Section 16 Planning Application for Proposed Mixed-Use Development (Proposed Flat with Permitted Commercial Uses) with Minor Relaxation of Building Height Restriction at Lot 4354 in D.D. 124, Kiu Tau Wai, Yuen Long (Application No. A/HSK/617)

Response to Departmental Comments

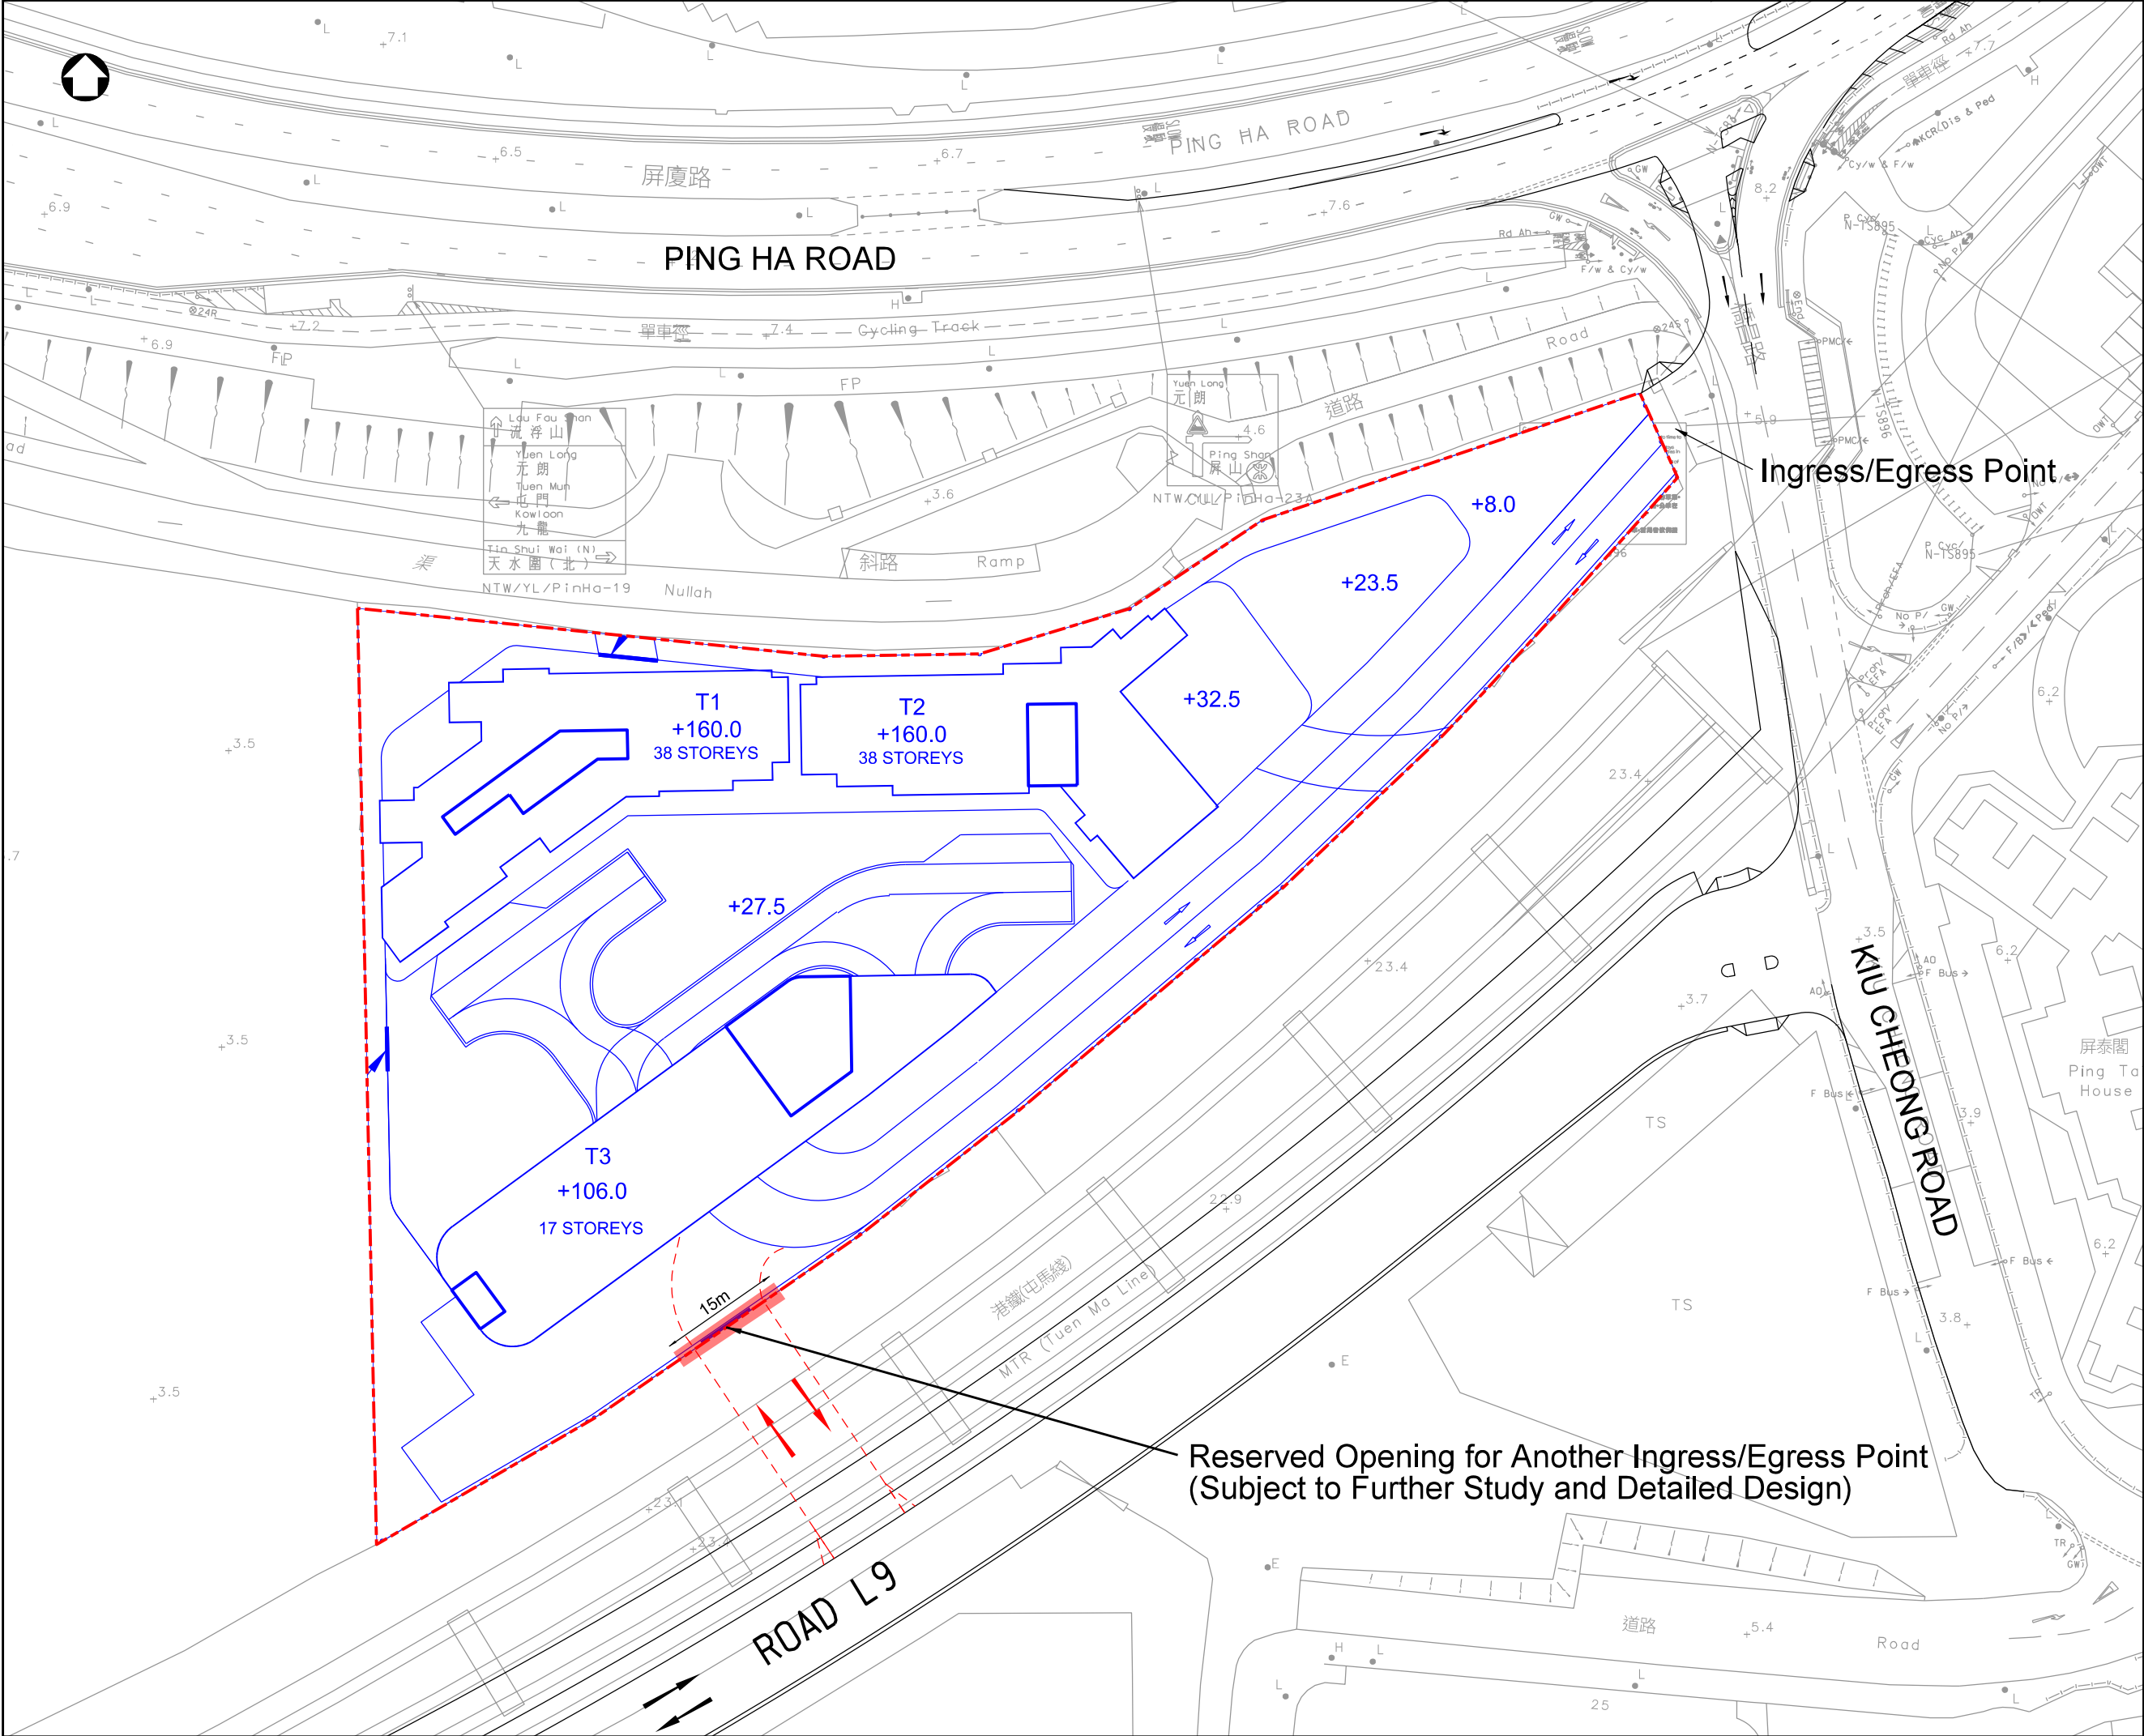
Departmental Comments	Responses to Comments
	<u>Comment on the Traffic Impact Assessment</u>	
8.4	Figure 2.5: there are typos on the road names. Please check.	Noted. Figure 2.5 of the TIA replacement pages under Attachment 3 has been revised accordingly.

FIGURE 3.1

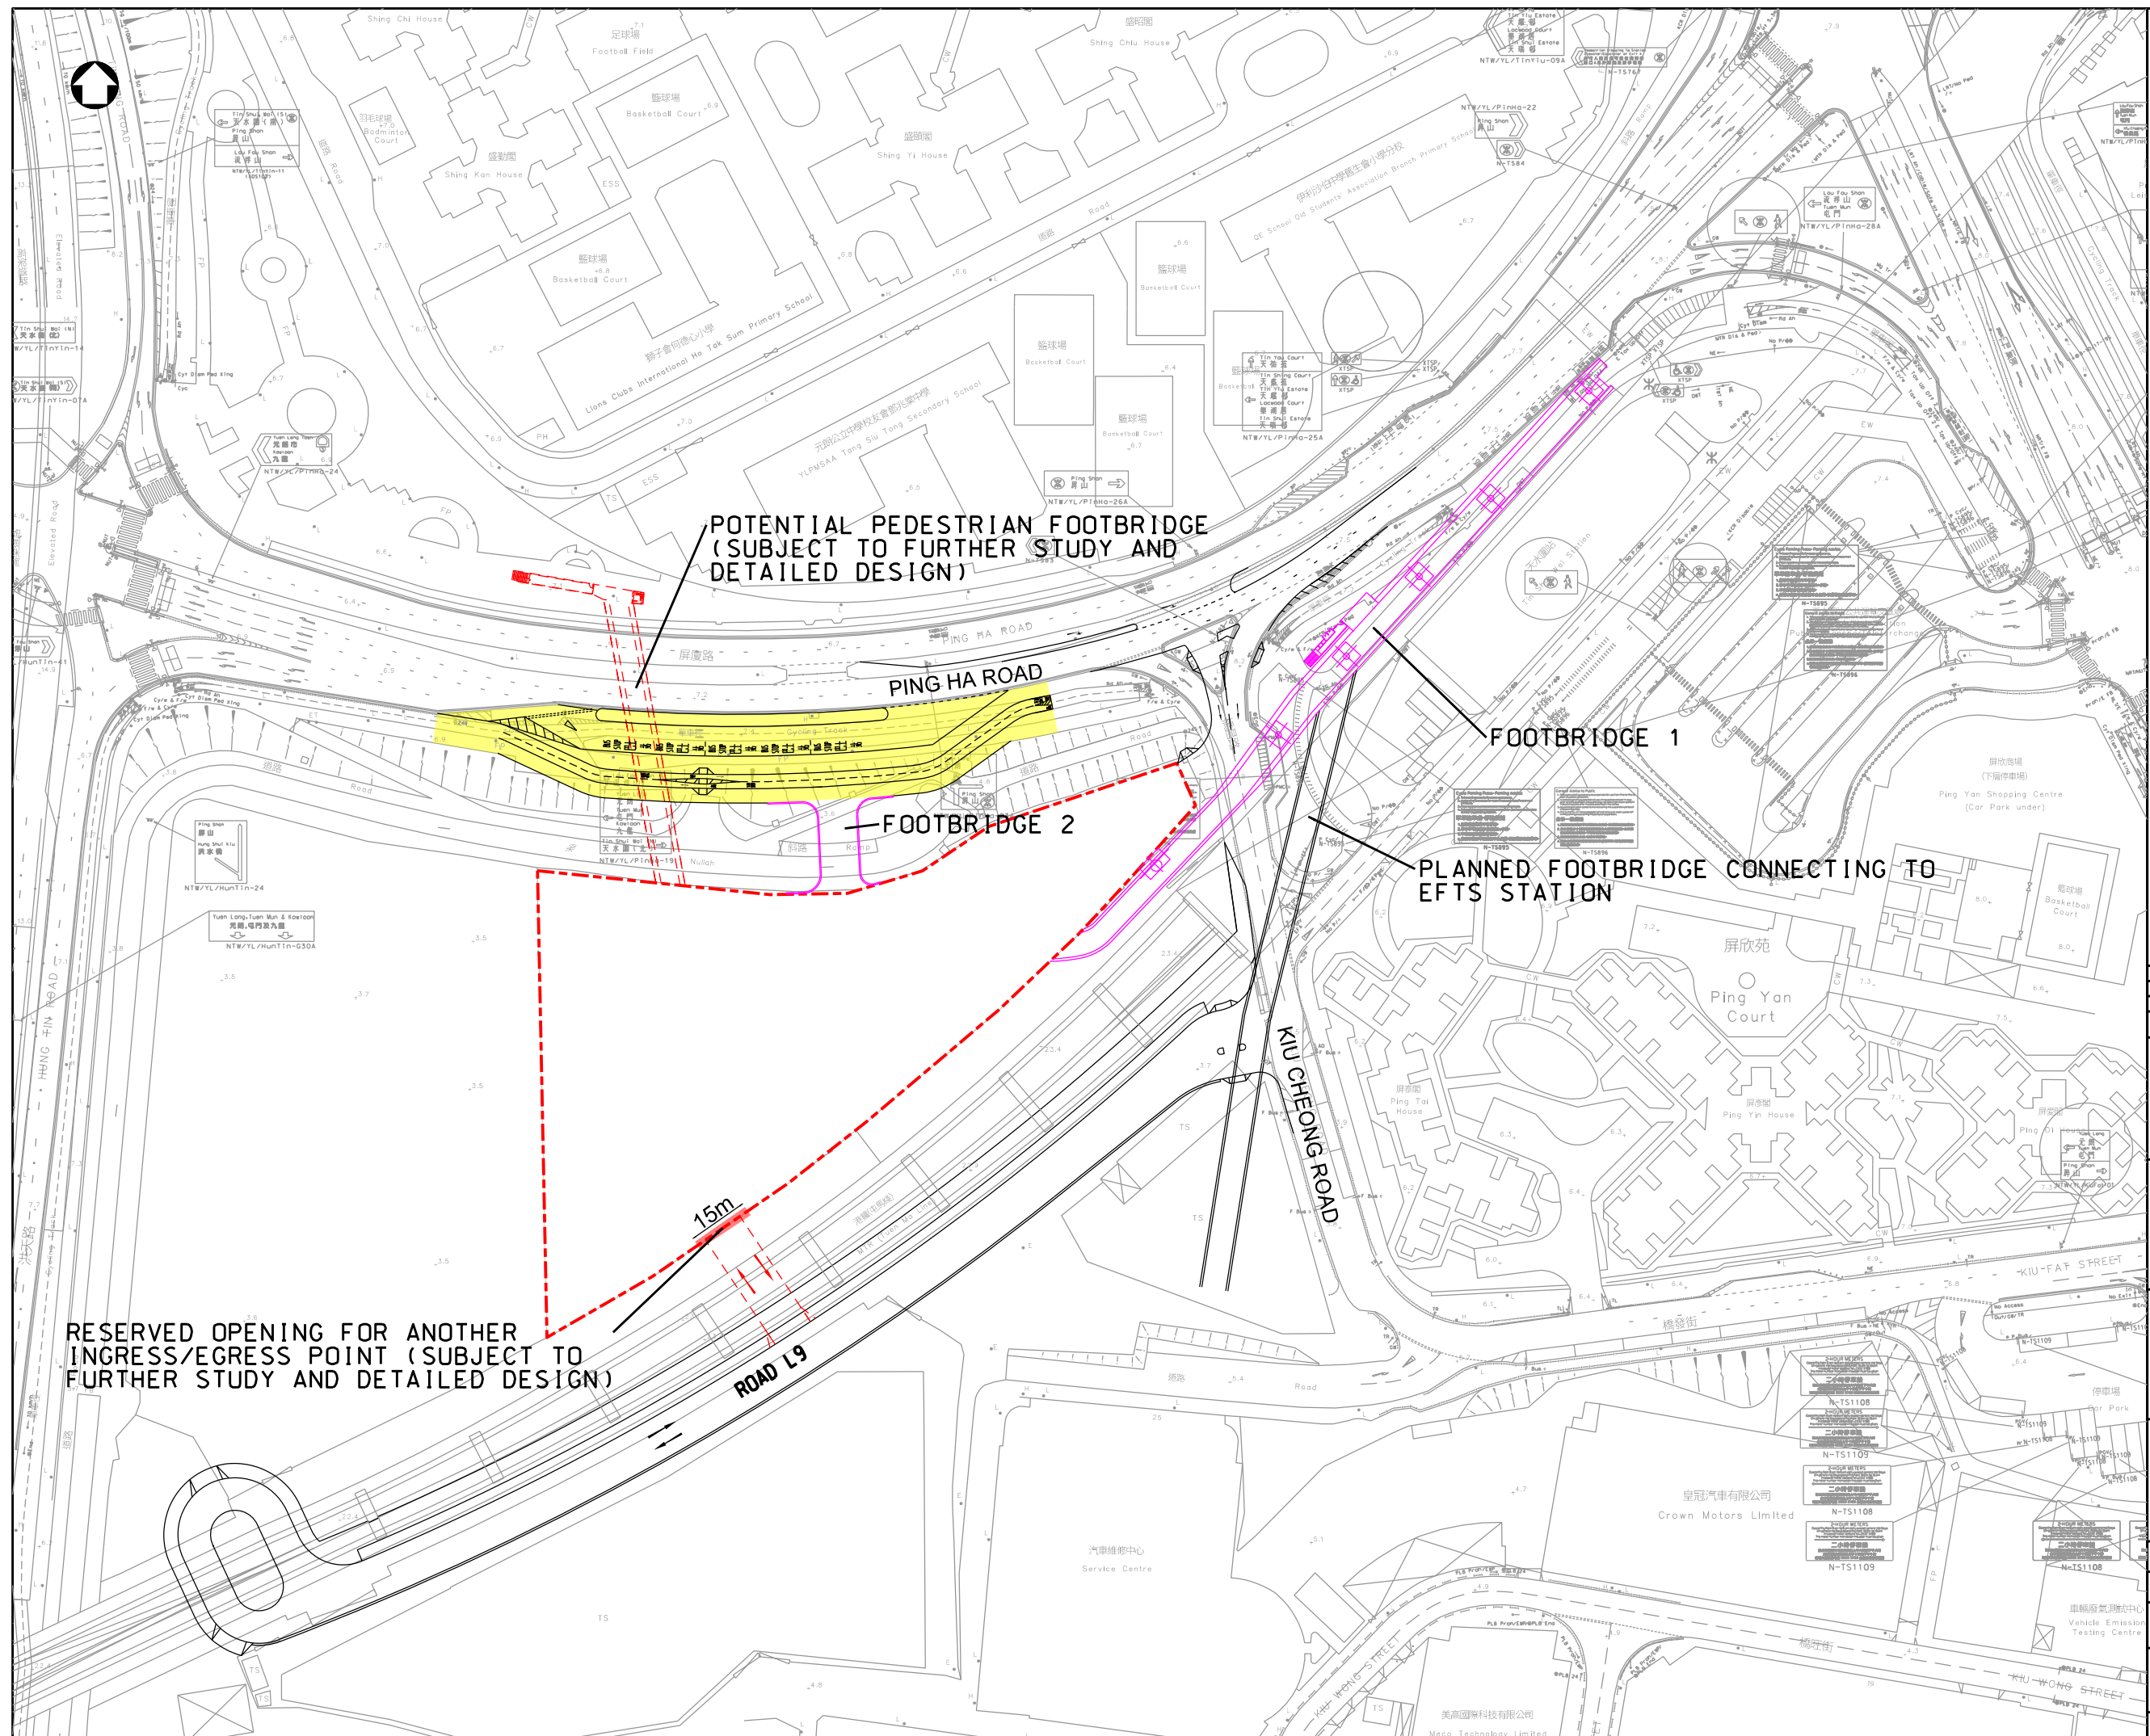
8.5	Figure 3.1: the proposed vehicular access point of the development is inconsistent with that shown in Figure 3.2. Please clarify.	Noted. Figure 3.1 of the TIA replacement pages under Attachment 3 has been revised accordingly.

Figure: 2.2	RAMBOLL
Title: Propose Road Traffic Noise Mitigation Measures	Drawn by: KK
Project: Section 16 Planning Application For Proposed Comprehensive Development At Lot No 4354 In Dd 124, Kiu Tau Wai, Ping Shan, Yuen Long	Checked by: TC
	Rev.: 1.2 Date: Aug 2026

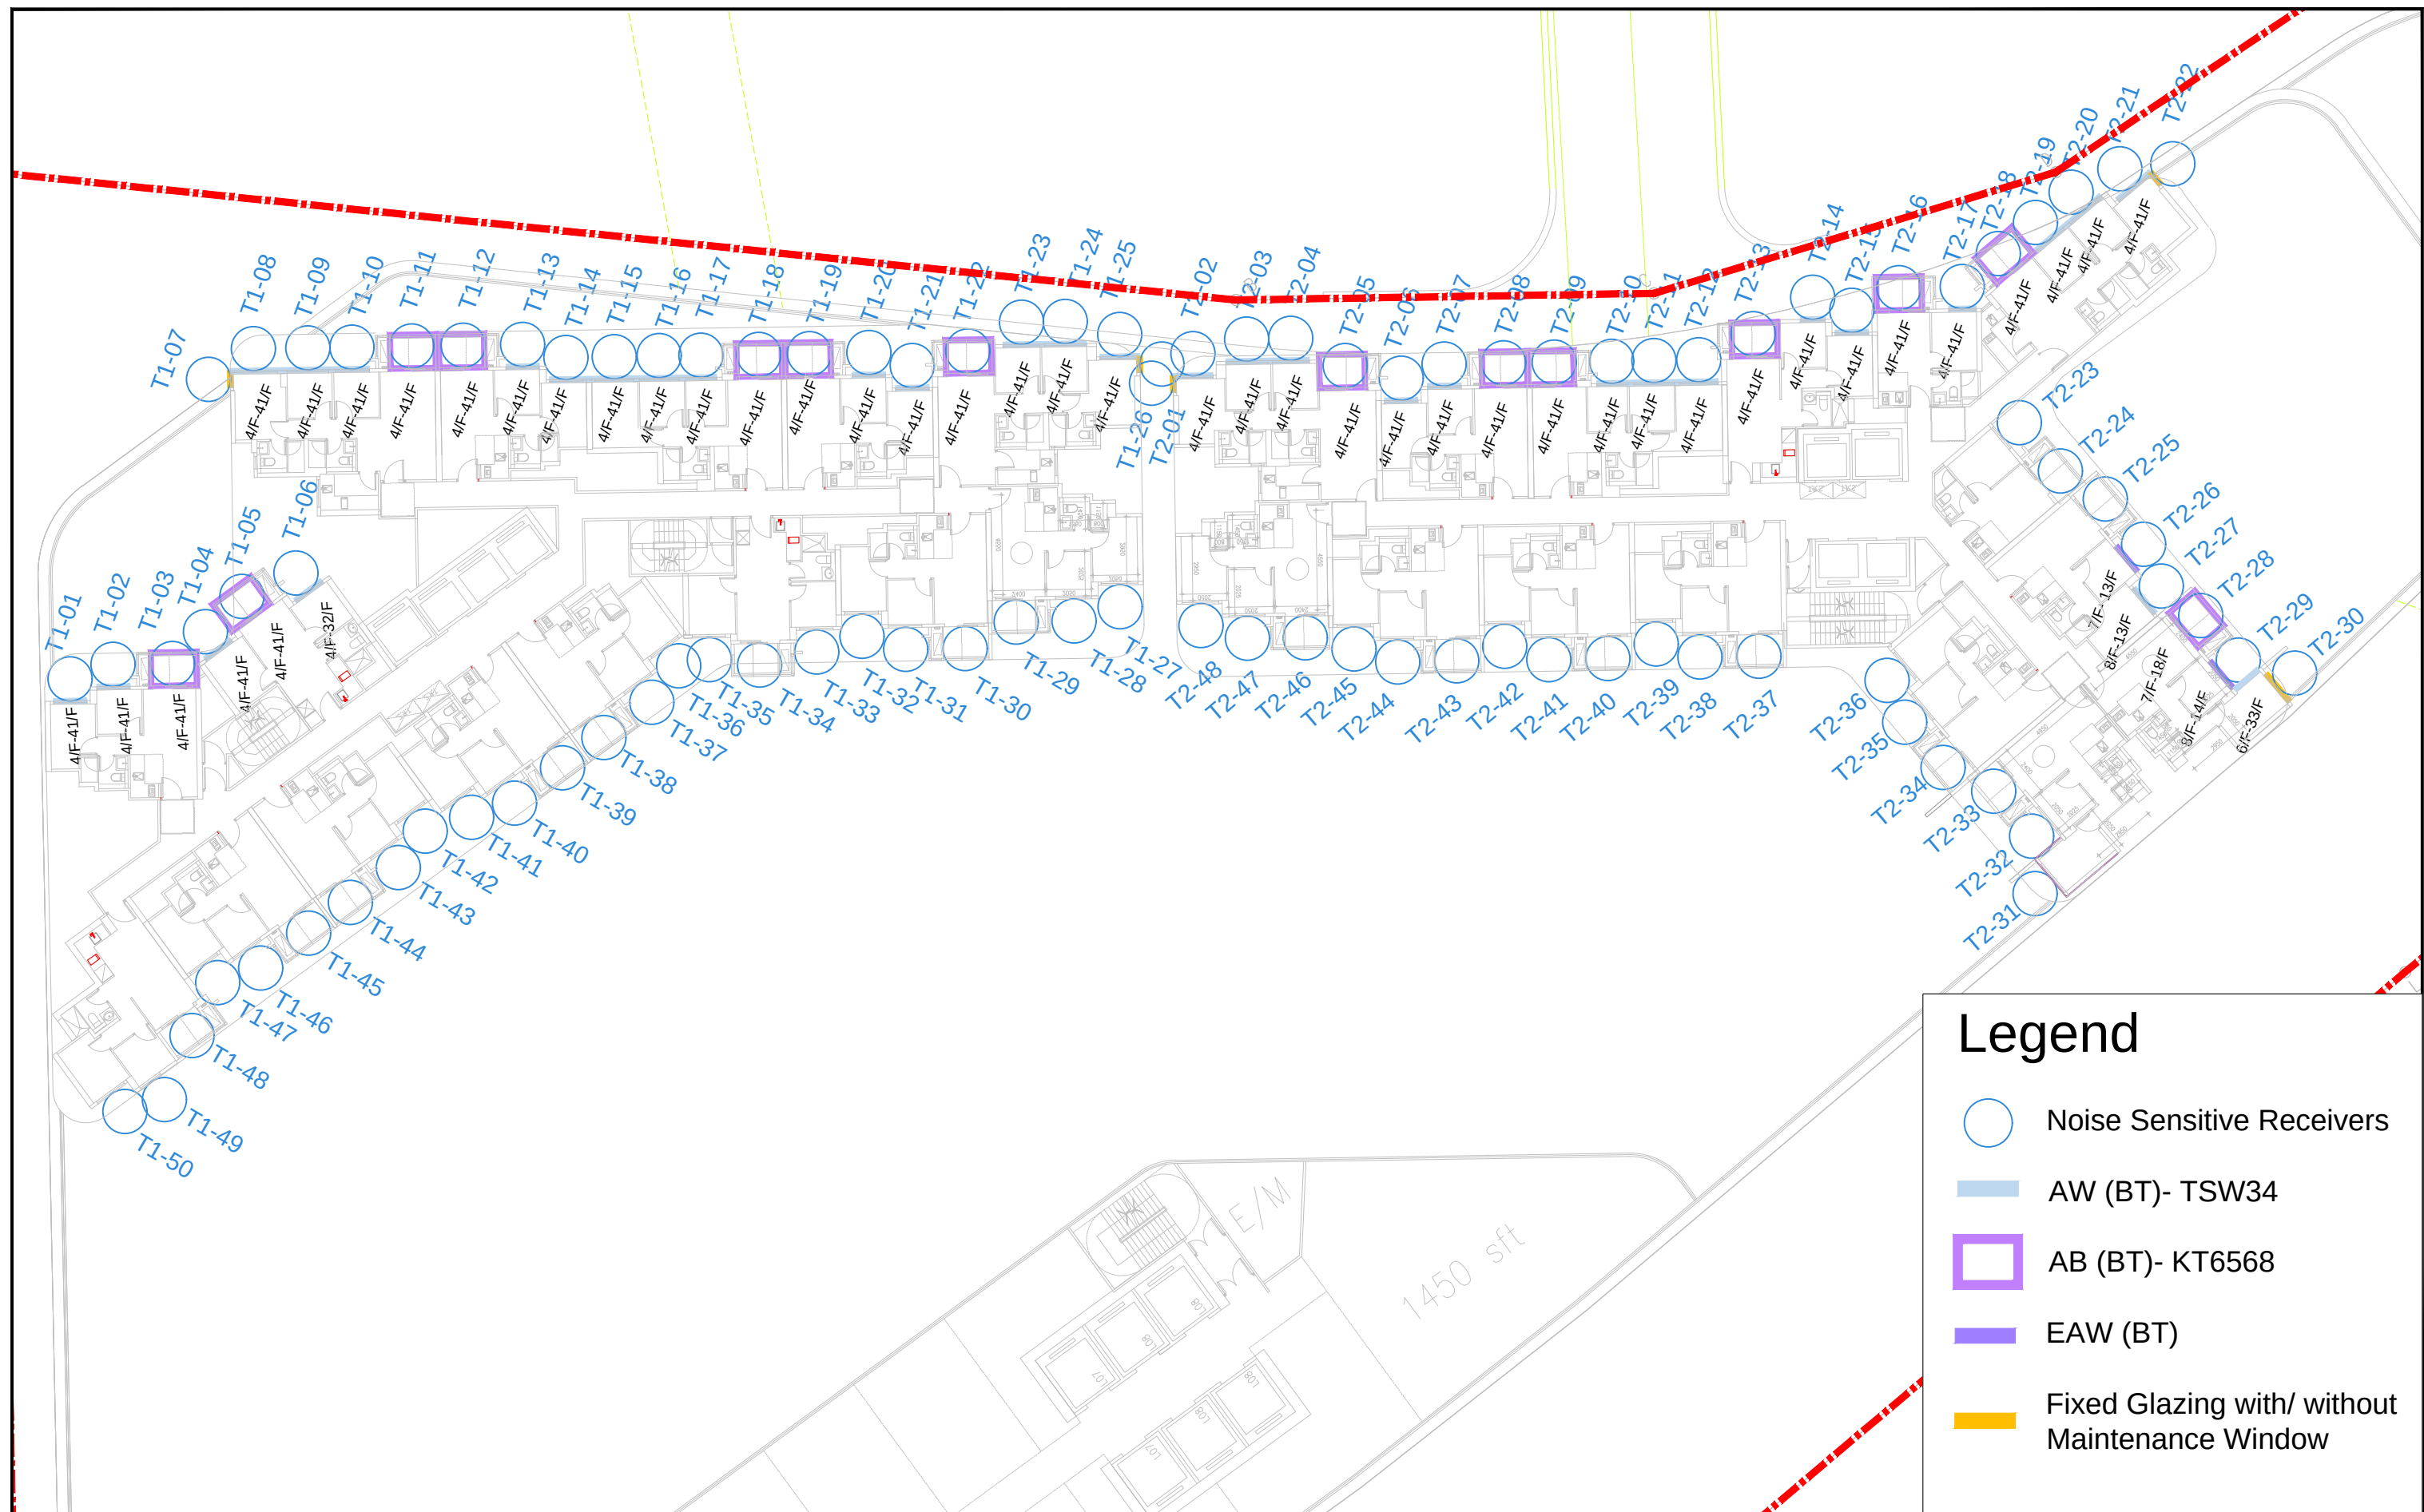
4.30	Figure 2.2 & Figure 3.2 – Different mitigation measures for same NAP (e.g. T2-30) are spotted under the traffic noise impact assessment and railway noise impact assessment respectively. Please review and revise to ensure the consistency.	Noted. Section 2.8.16, Table 2.2, Figure 2.2, Appendix 2.4, Appendix 2.5 and Appendix 2.6 of the EA replacement pages under Attachment 4 have been revised accordingly.
